Summary Document for Replication of USBR Rule of Thumb Curve for Shasta Storage and CCR Temperature  
 Prepared by the Southwest Fisheries Science Center on December 7<sup>th</sup>, 2016

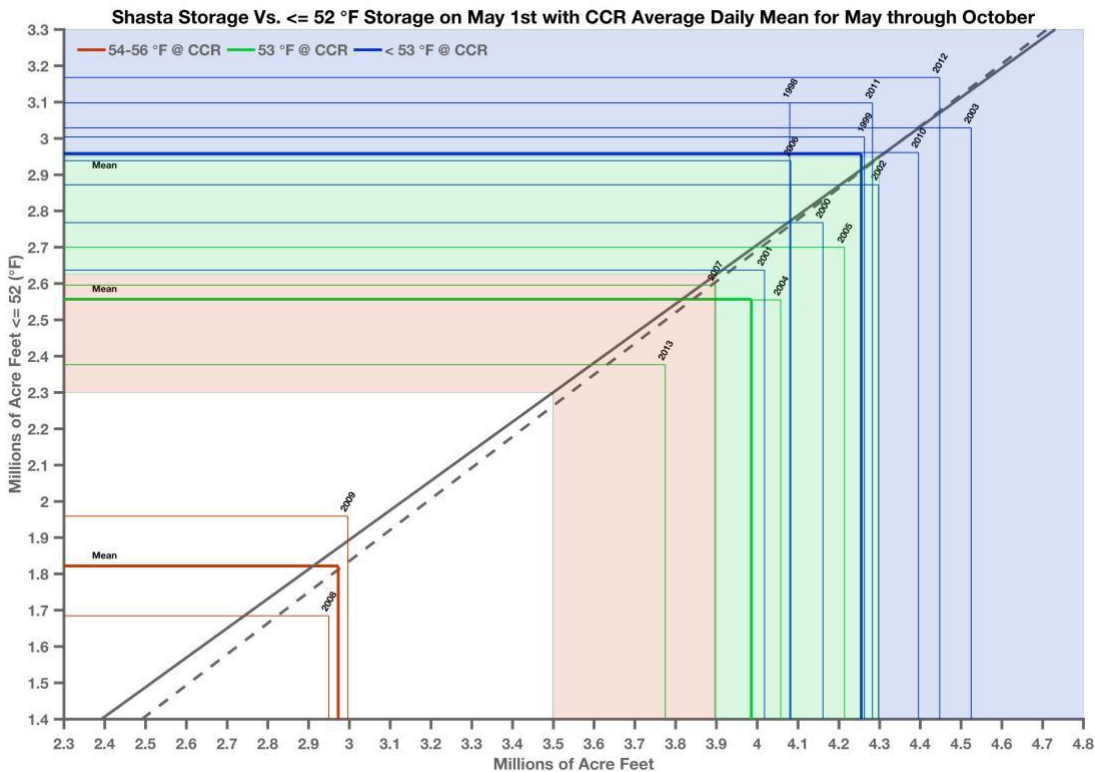
- USBR estimates do not align with NOAA estimates calculated from CDEC and USBR profile data under given assumptions. To resolve, some descriptions of the methods and data used to produce USBR estimate are needed.
- Trend between USBR and NOAA estimates are consistent that greater total/cold pool storage are associated with colder average temperatures at CCR (linear models between cold pool and storage relationship are also similar with USBR estimate slight biased upwards).
- USBR estimates indicates no overlap between CCR temperature criteria and total/cold pool storage while NOAA estimates indicates some overlap (especially under average daily maximum method), more clearly indicating other factors associated with CCR temperatures aside from May 1<sup>st</sup> total/cold pool storage.
